REQ. ITEM	PART NO.	DESCRIPTION	SYMBOL
	.081 THK.	THE TECHNICAL MATERIEL CORP.	
	Aluminum	MAMARONECK, NEW YORK	
	5052 - H32	CHASSIS, MAIN	
	464-26-58	DRAWN	ELEC. DES. APP.
	5-404 YEL. TRIDITE	CHECKED	MECH. DES. APP.
		FINAL APPROVAL	
		SHEET 1	MS-1223 H
			SHEET 1 OF 2

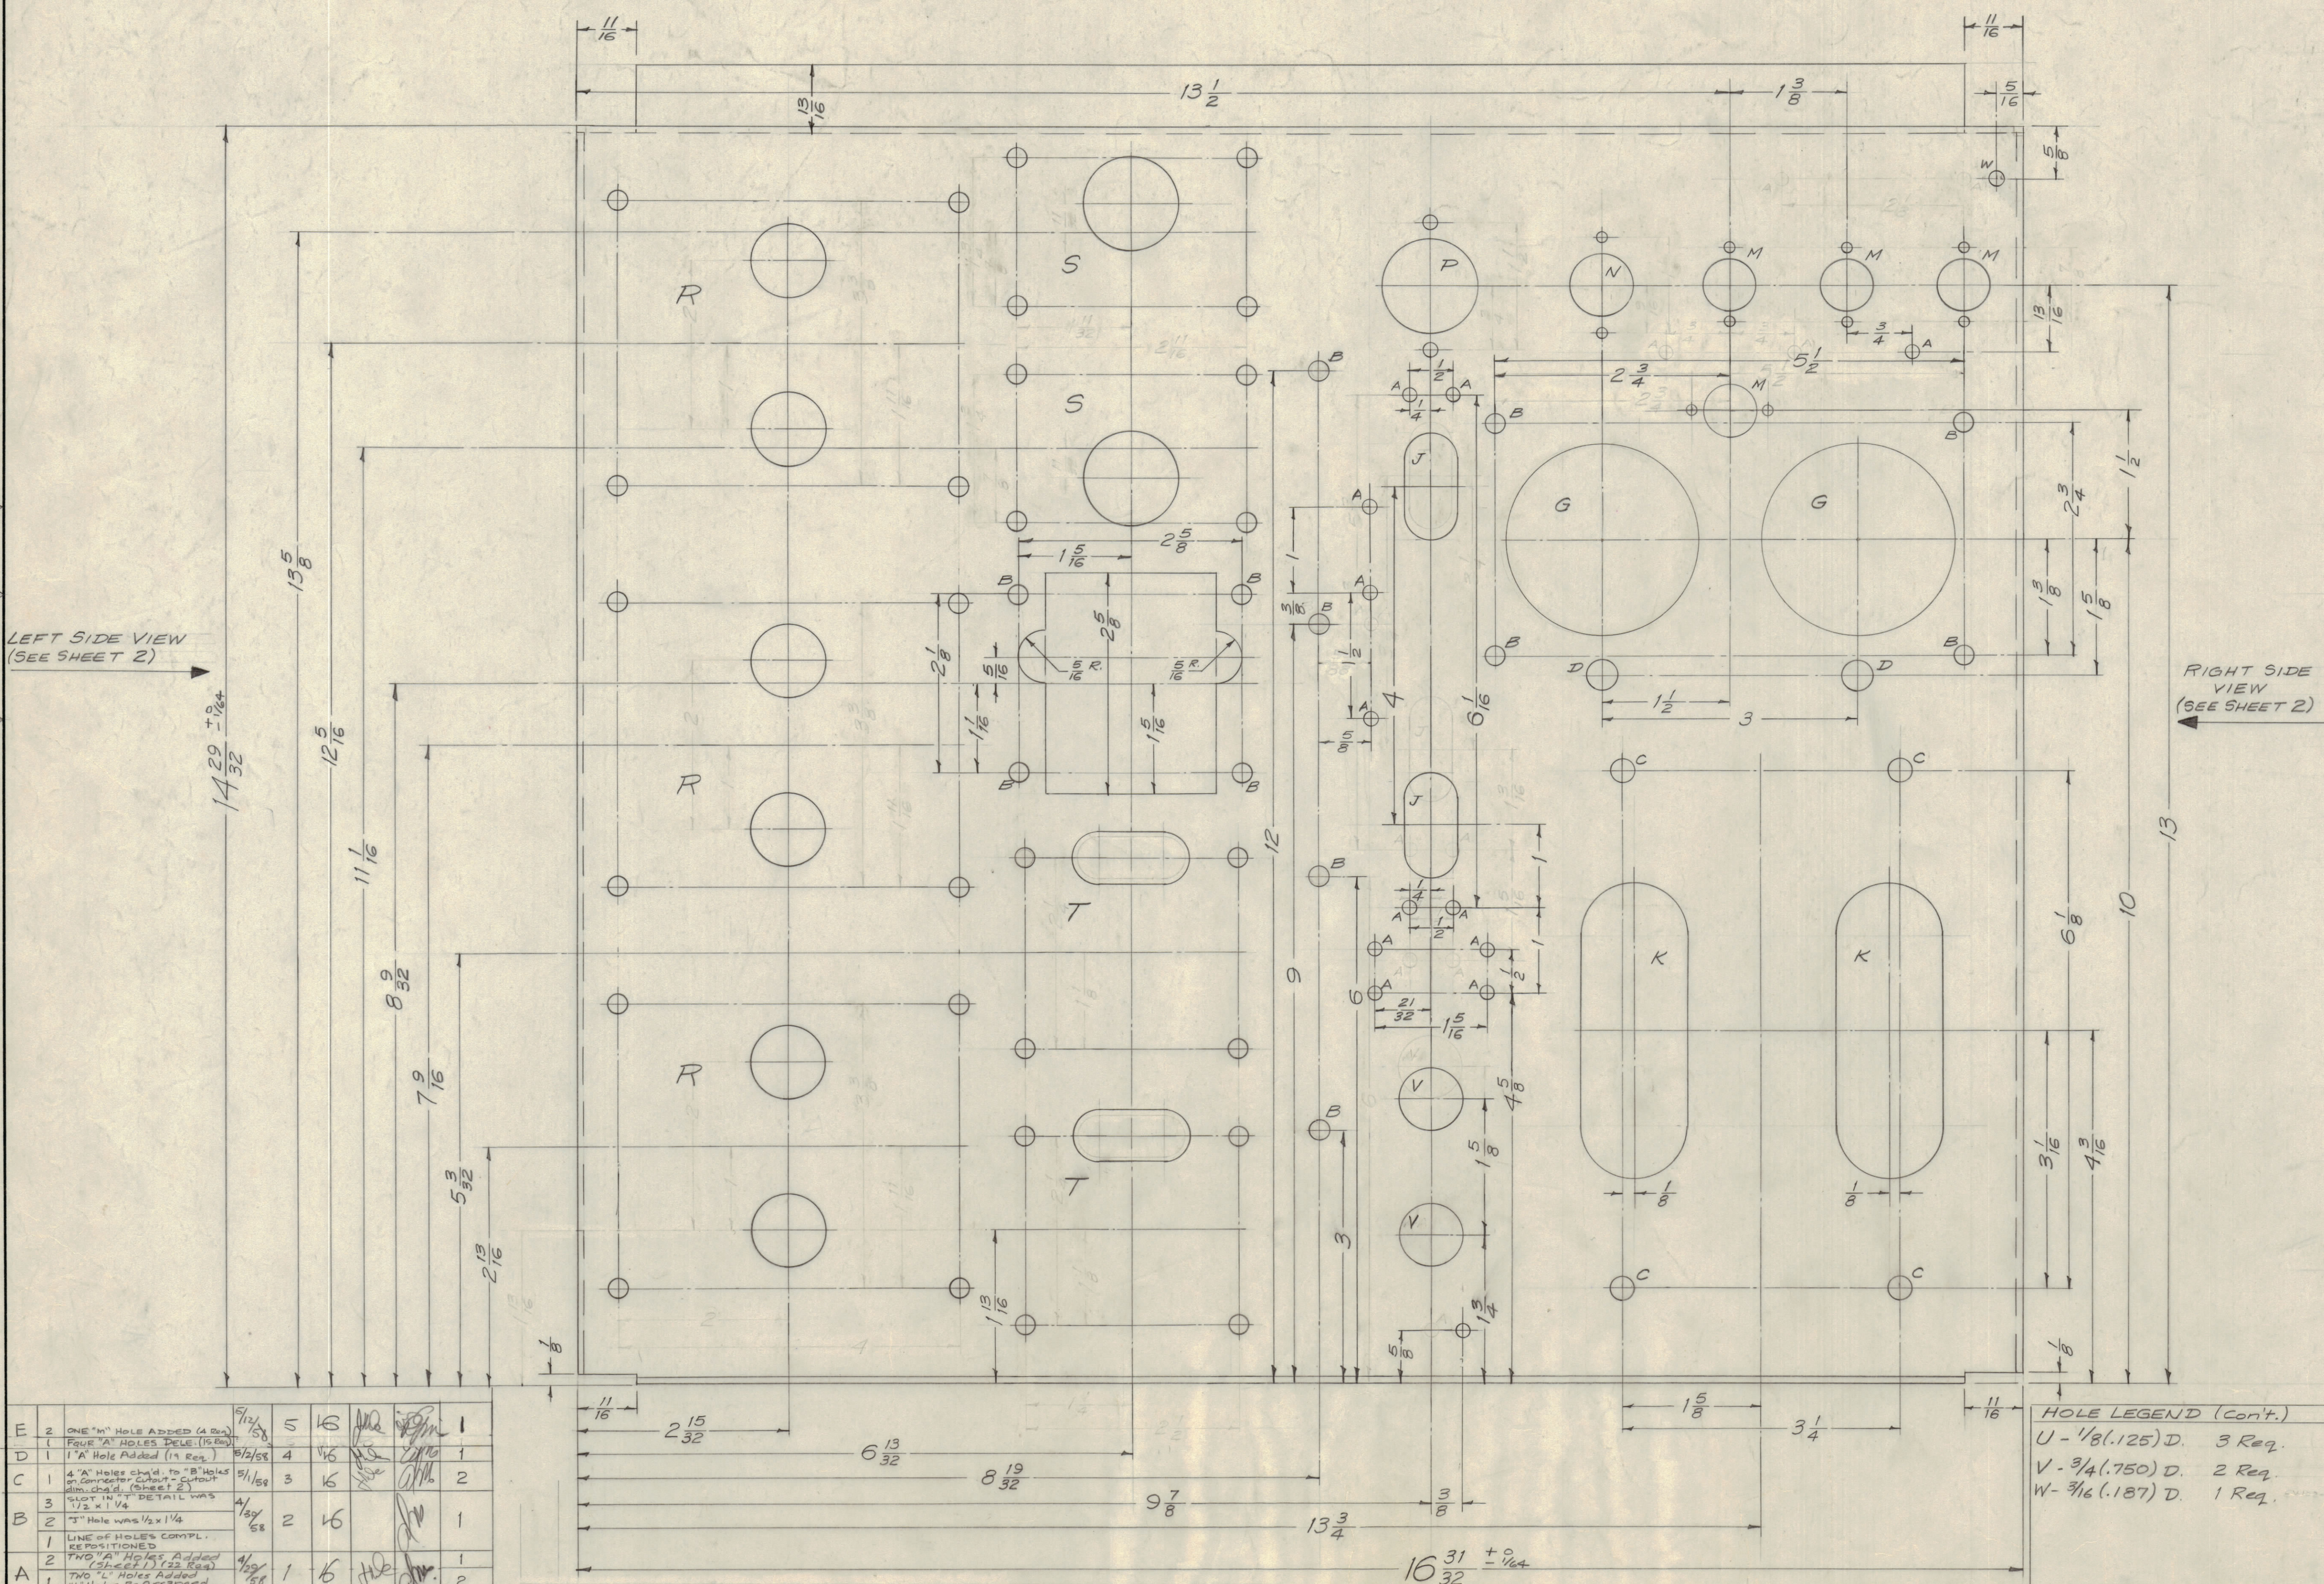
ISSUE	ITEM	CHANGED FROM	DATE	CN. NO.	DRAFTS	CHECKER	ENG. APP.	SHEET NO.
E	2	ONE "A" HOLE ADDED (4 Req.)	5/15/58	5	10	[Signature]	[Signature]	1
D	1	FOUR "A" HOLES DELETED (15 Req.)	5/15/58	4	10	[Signature]	[Signature]	1
C	1	4 "A" HOLES CHANGED TO "B" HOLES ON CONNECTOR CUTOFF - CUTOFF ALLOWED. (SEE SHEET 2)	5/15/58	3	15	[Signature]	[Signature]	2
B	3	3 "A" HOLES ADDED (12 Req.)	4/13/58	2	16	[Signature]	[Signature]	1
A	1	ONE "A" HOLE ADDED (1 Req.)	4/13/58	1	16	[Signature]	[Signature]	2

ISSUE	ITEM	REVISION	DATE	CN. NO.	DRAFT	CHK	APP	SHEET NO.
H	1	S-404 YEL. TRIDITE WAS 3-191 CAUSTIC DIB	7/16/58	1001	16	[Signature]	[Signature]	1#2
G	1	BEAK UP BENT OVER. (WAS BENT IN) OVER THE HOLE	7/16/58	1001	16	[Signature]	[Signature]	1#2
F	1	ONE "A" HOLE MOVED, TWO "A" HOLES ADDED	5/15/58	6	16	[Signature]	[Signature]	1
